PRODUCT/PROCESS CHANGE NOTICE (PCN)

| PCN #: TB-0609-03 DATE: 06-Oct-2006 Product Affected: All square PQFP and TQFP, MLP Dual, QFP-N, VFQFP-N packages shipped in Tape and Reel Date Effective: 06-Nov-2006 | MEANS OF DISTINGUISHING CHANGED DEVICES: <input type="checkbox"/> Product Mark <input type="checkbox"/> Back Mark <input type="checkbox"/> Date Code <input checked="" type="checkbox"/> Other Starting 06-Nov-2006 |

ATTACHMENT I - PCN #: TB-0609-03

PCN Type: To comply to current EIA Standard (EIA-481-C) requirement.

FROM:

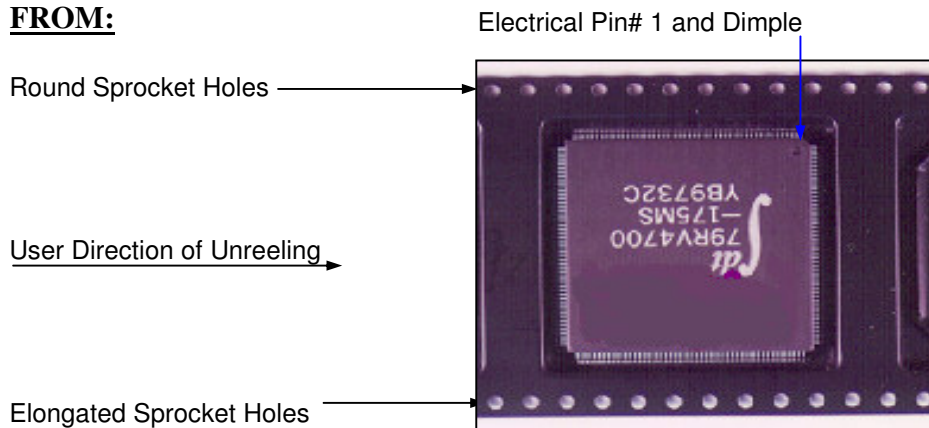
Detail of Change: This change will be implemented on all square PQFP and TQFP, MLP Dual, QFP-N, VFQFP-N packages.

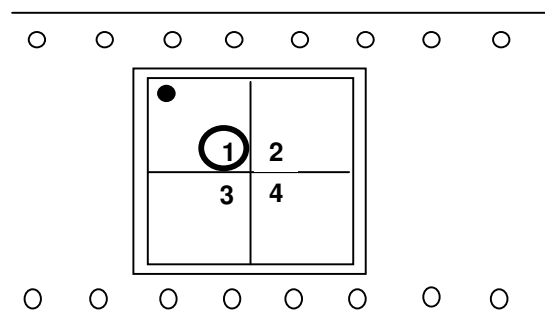
Additional label as shown below will be placed on the intermediate box (pizza box) to alert customer of this change. Label will be placed starting 06-Nov-2006 until 06-Nov-2007. However, please take note that IDT will continue to ship products in existing loading orientation until the inventory has been depleted. Customer may receive shipments in existing or new loading orientation.

● Pin One in Quadrant 1
